# Worcestershire Rail Investment Strategy Consultation Report

Autumn 2017

**1.1** In 2016 Worcestershire County Council commissioned SLC Rail to develop a Rail Investment Strategy for Worcestershire (WRIS) that can be used to inform the development of the 4th Local Transport Plan (2017 – 2030).

Figure 1 – Worcestershire rail infrastructure

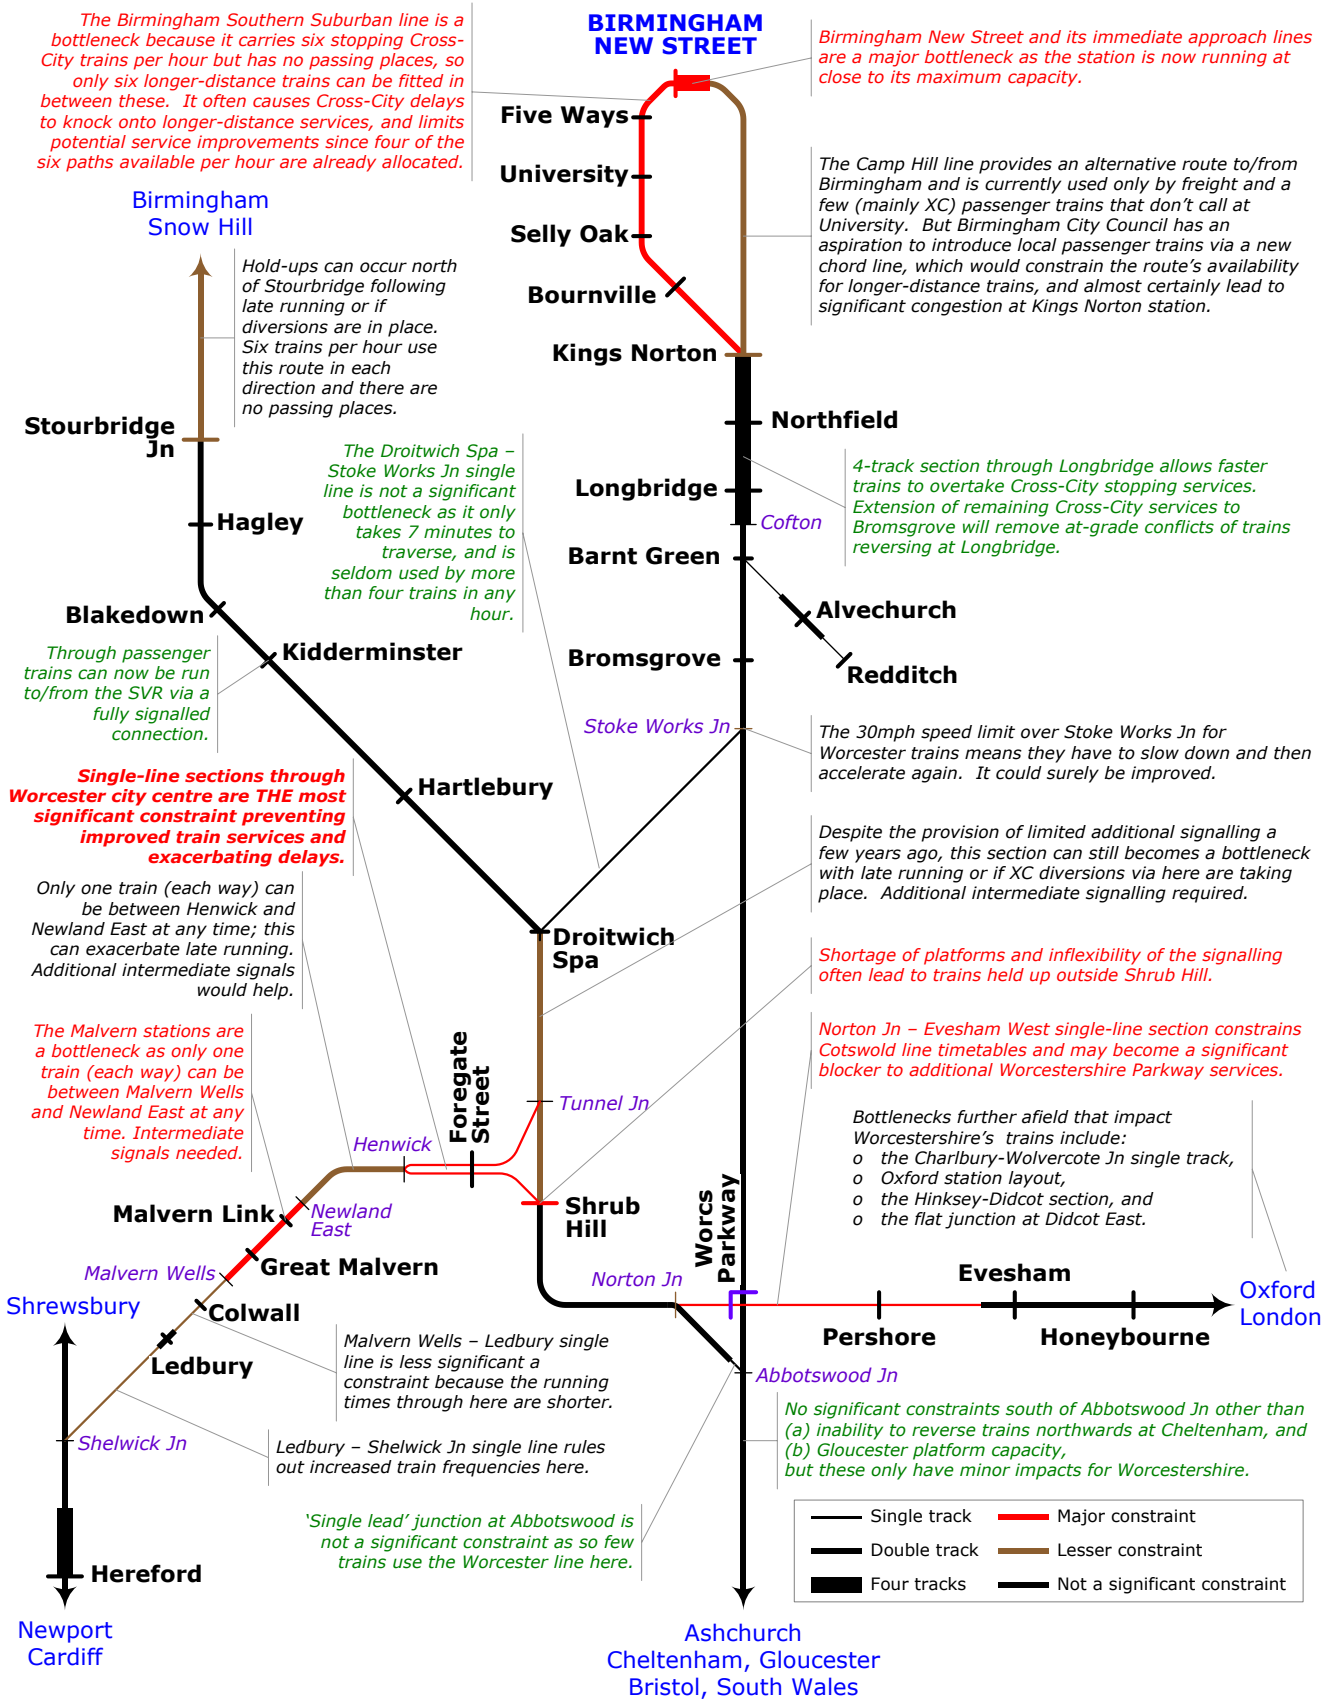
The following diagram shows the current rail network, highlighting its capacity constraints and bottlenecks:

Within the current Worcestershire infrastructure, the principal constraints that prevent or severely limit potential service improvements have been identified in section 2.7 and on Figure 1 above:

**Figure 2 – Current Worcester track layout and signalling**

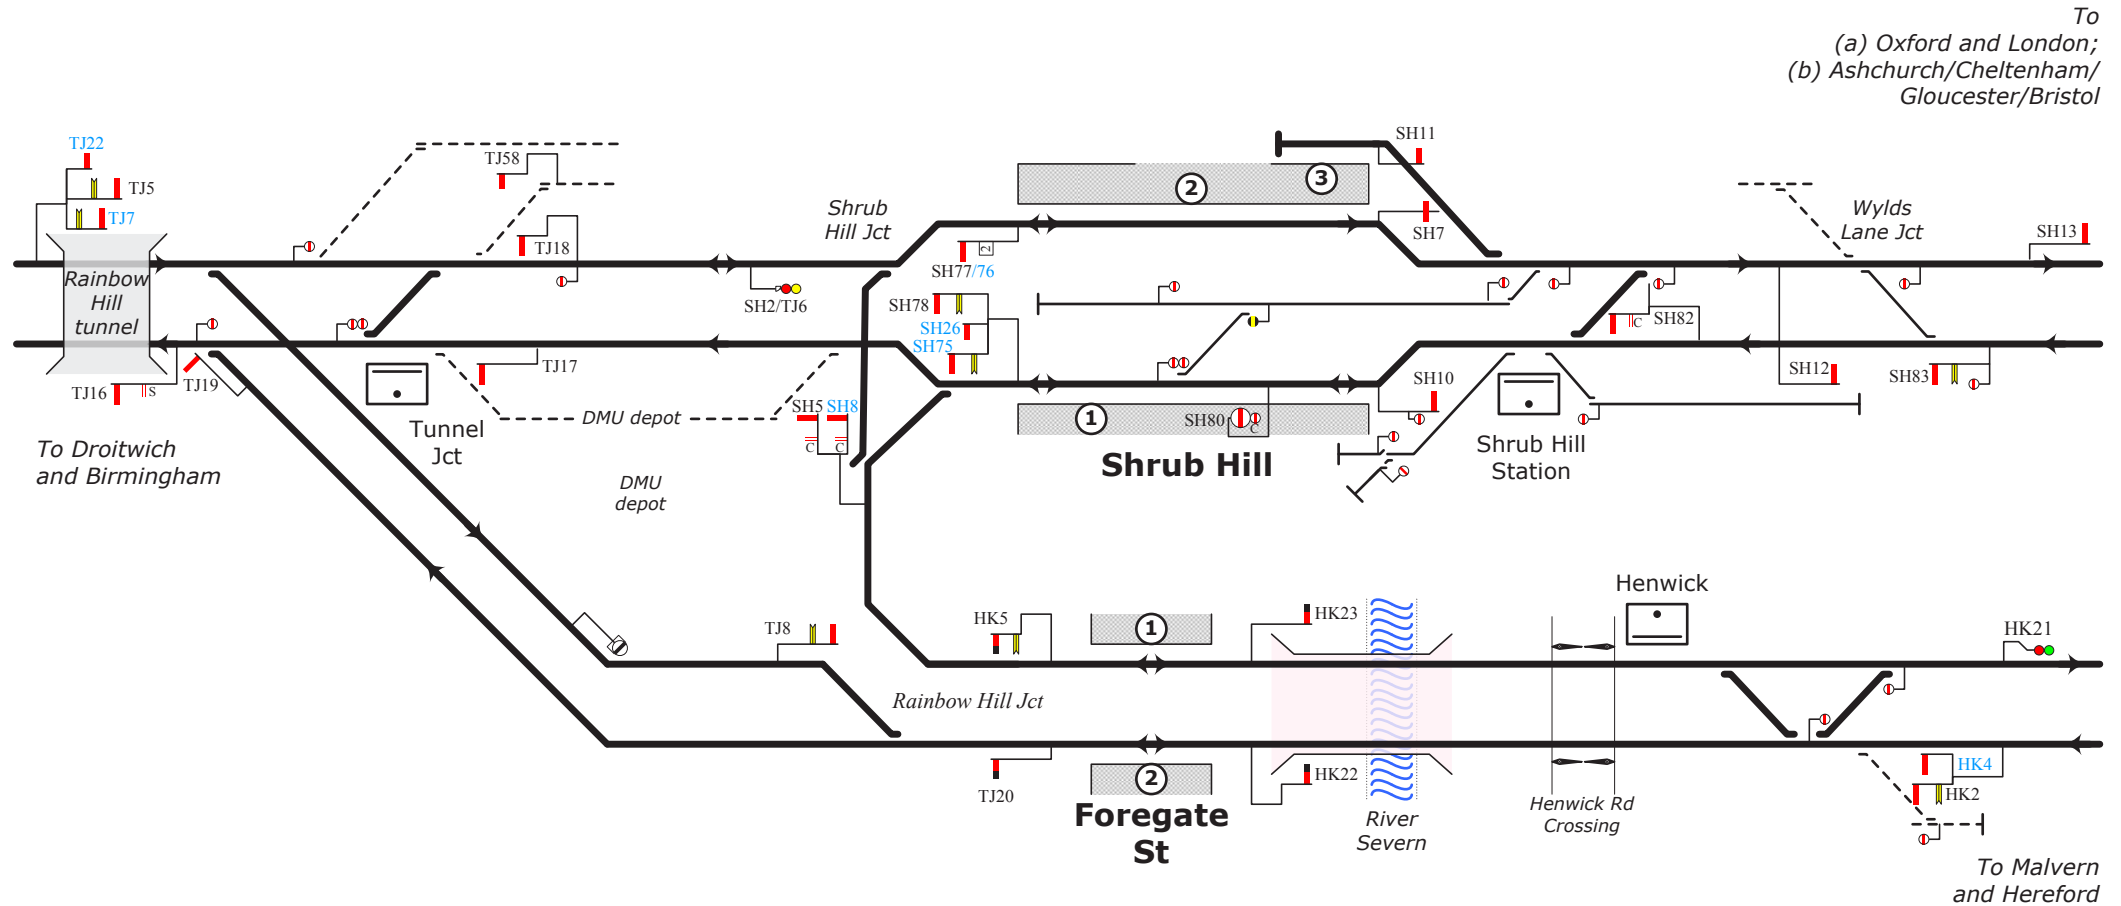
The two lines through Foregate Street station are separate single line sections. The one through Platform 1 must be used by all trains to/from Shrub Hill, including all GWR trains, while the line through Platform 2 is used by London Midland trains to/from Birmingham that do not call at Shrub Hill.

**Figure 3 – Minimum changes needed to address Worcester single-line section bottlenecks**

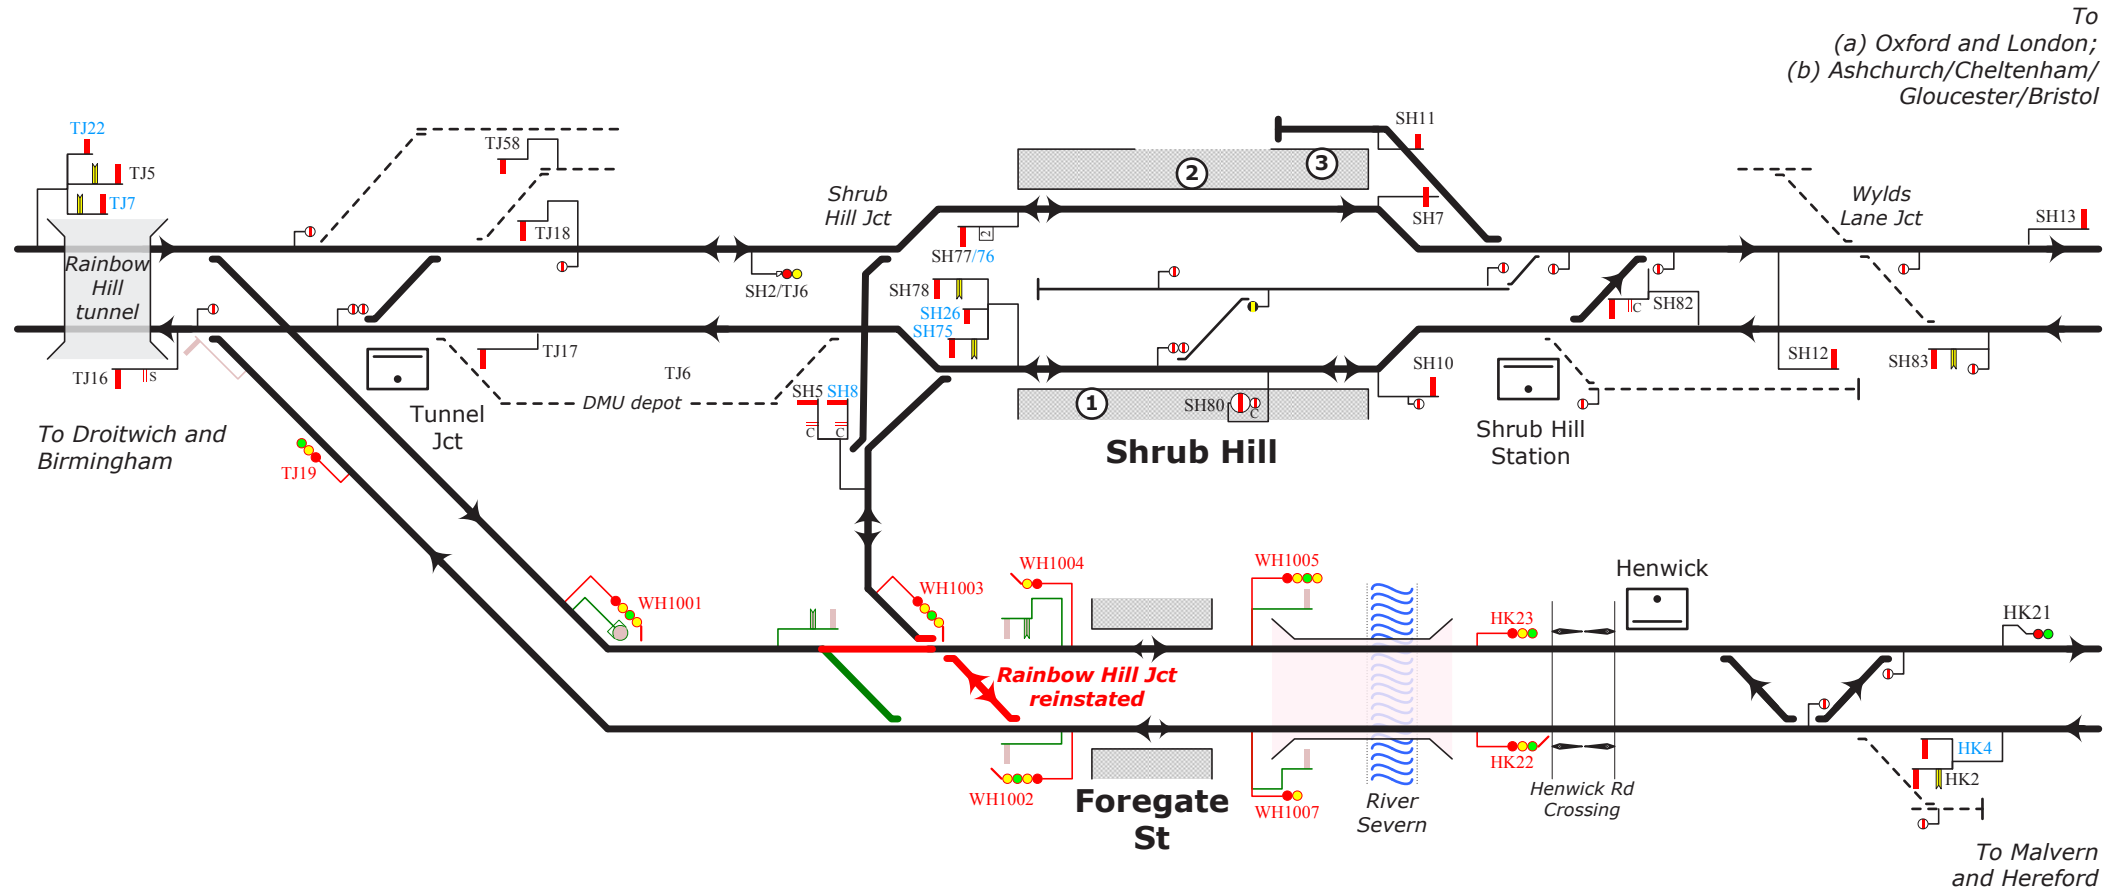
The following diagram shows a minimum set of improvements that would restore double-track working to most of the city centre area and provide considerable new operational flexibility:

This scheme reinstates double track everywhere except for the very short section between Rainbow Hill Jn and Shrub Hill, and provides bi-directional running between Henwick and Rainbow Hill Jn for added flexibility. It would also allow trains from Shrub Hill to call at Foregate St but then continue towards Birmingham, and correspondingly in the opposite direction, which is not possible at present!

**Figure 4 – Current Malvern signalling arrangements**

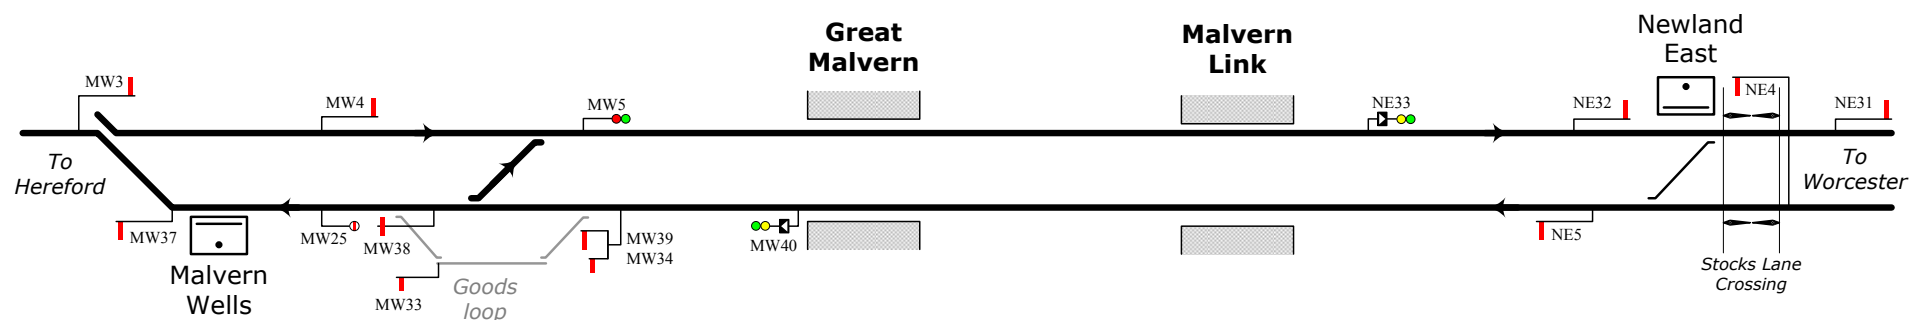
Two potential schemes are suggested to improve this, the second option being somewhat more costly but providing shorter headways through this section. The first option, which introduces a new crossover at Great Malvern and intermediate signals between there and Newland East, is shown below:

**Figure 5 – Malvern improvements – Option A**

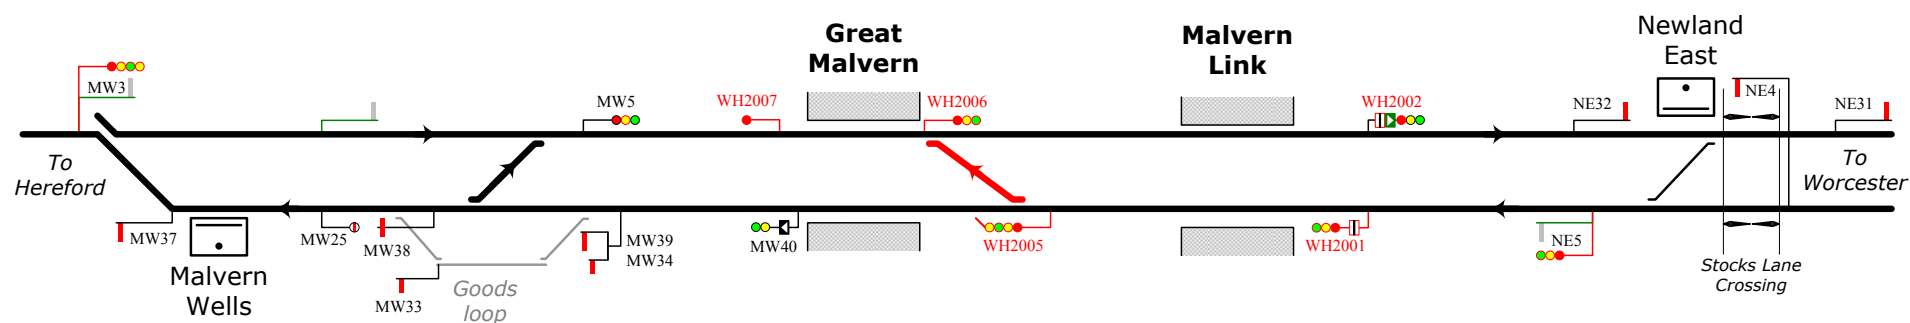
The new crossover allows terminating trains to run directly into Platform 1 at Great Malvern, from where they can then depart directly on their return journeys.

**Figure 6 - Malvern improvements – Option B**

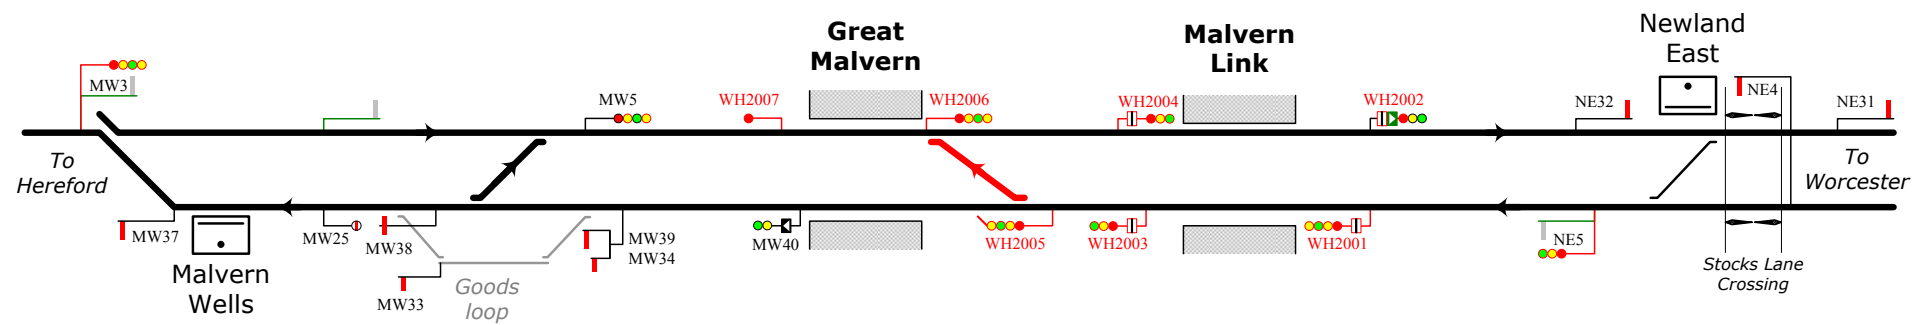
The second option is similar but with the addition of a further pair of intermediate signals between Great Malvern and Malvern Link:

Further benefits from either of these options could also be obtained by also providing additional ('intermediate block') signals in each direction between Newland East and Henwick.

**Figure 7 – Initial Worcestershire Parkway layout, signalling and constraints**

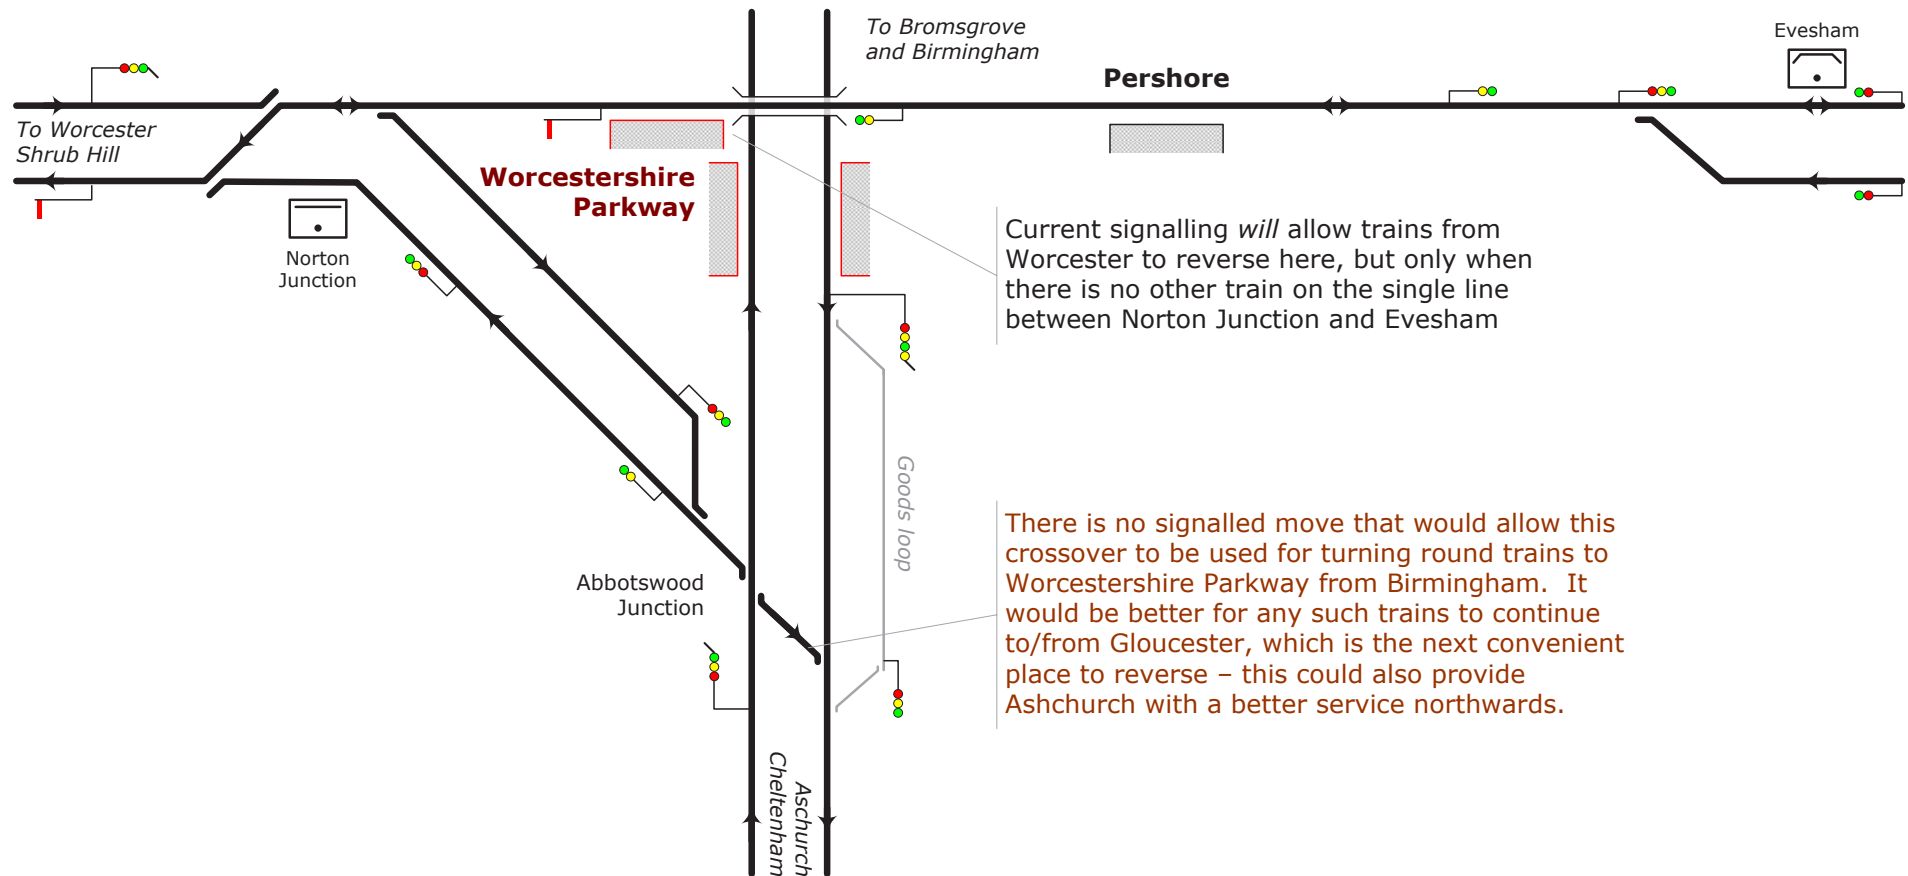
Short of full redoubling to Evesham, some less costly options are available to reduce or eliminate the constraints on reversing trains. The following options are presented in increasing order of complexity/cost and of utility:
